VIKING PARK SUBDIVISION

APPLICATION NUMBER 8 DATE September 6, 2007

DETAIL SITE PLAN

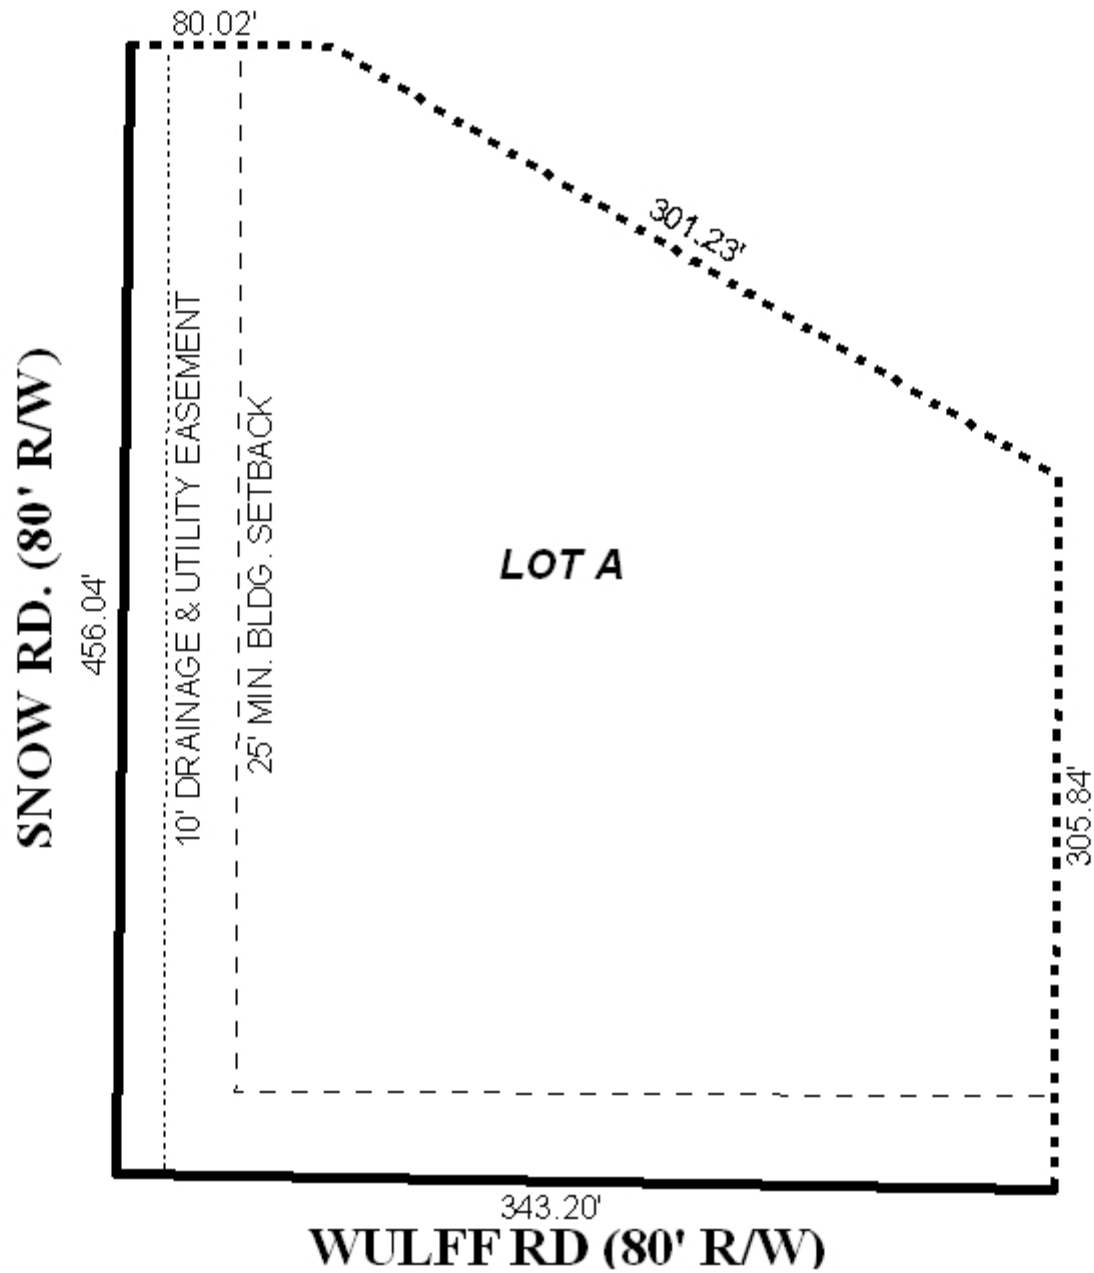
Wulff Road and Snow Road, which have existing rights-of-ways of 80-feet, are shown as major streets on the Major Street Plan, and as such require 100-foot rights-of-ways; therefore, the dedication of sufficient rights-of-ways to provide 50-feet from the centerline should be required, as depicted on the plat. Additionally, as a means of access management, a note should be placed on the final plat stating that Lot A is limited to two curb-cuts onto Wulff Road and two curb-cuts onto Snow Road, with the size, design and location of the curb-cuts to be approved by Mobile County Engineering.

A condition of approval for this site under the Phase II application was that the corner at the intersection of Snow and Wulff Roads be designed to comply with Section V.D.6. of the Subdivision Regulations, however, the plat does not appear to reflect this requirement. As both Wulff and Snow Roads are proposed major streets, the corner should be modified to provide an appropriate radius, to be approved by Mobile County Engineering.

If any common areas or detention common areas are provided, they should be depicted and labeled on the plat, and a note should be placed on the final plat stating that maintenance of the detention area shall be the responsibility of the property owners.

While the site is in Mobile County, it will have to comply with the City of Mobile storm water and flood control ordinances. A note should be placed on the final plat stating that the development will be designed to comply with the storm water detention and drainage facility requirements of the City of Mobile storm water and flood control ordinances, and requiring submission of certification from a licensed engineer certifying that the design complies with the storm water detention and drainage facility requirements of the City of Mobile storm water and flood control ordinances prior to the issuance of any permits. Certification is to be submitted to the Planning Section of Urban Development and County Engineering.

A note should be placed on the Final Plat, as depicted on the preliminary plat, stating that any lots which are developed commercially and adjoin residentially developed property must provide a buffer, in compliance with Section V.A.7. of the Subdivision Regulations.

- 1) dedication of right-of-way sufficient to provide a minimum of 50-feet, as measured from the centerline of Wulff and Snow Roads, as depicted;
- 2) adjustment of the property line at the intersection corner to provide an appropriate radius consistent with Section V.D.6. of the Subdivision Regulations, to be approved by Mobile County Engineering;

- 3) adjustment of the 25-foot minimum building setback line to accommodate condition number 2;
- 4) placement of a note on the final plat stating that Lot A is limited to two curb-cuts onto Wulff Road and two curb-cuts onto Snow Road, with the size, design and location of all curb-cuts to be approved by Mobile County Engineering;

- 5) revision of the plat to label Lot A with its size in square feet (in addition to the acres), or placement of a table on the plat with the same information;

- 6) placement of a note on the plat stating that the development will be designed to comply with the storm water detention and drainage facility requirements of the City of Mobile storm water and flood control ordinances, and requiring submission of certification from a licensed engineer certifying that the design complies with the storm water detention and drainage facility requirements of the City of Mobile storm water and flood control ordinances prior to the issuance of any permits. Certification is to be submitted to the Planning Section of Urban Development and County Engineering.; and

- 7) placement of a note on the final plat stating that any lots which are developed commercially and adjoin residentially developed property must provide a buffer, in compliance with Section V.A.7. of the Subdivision Regulations.
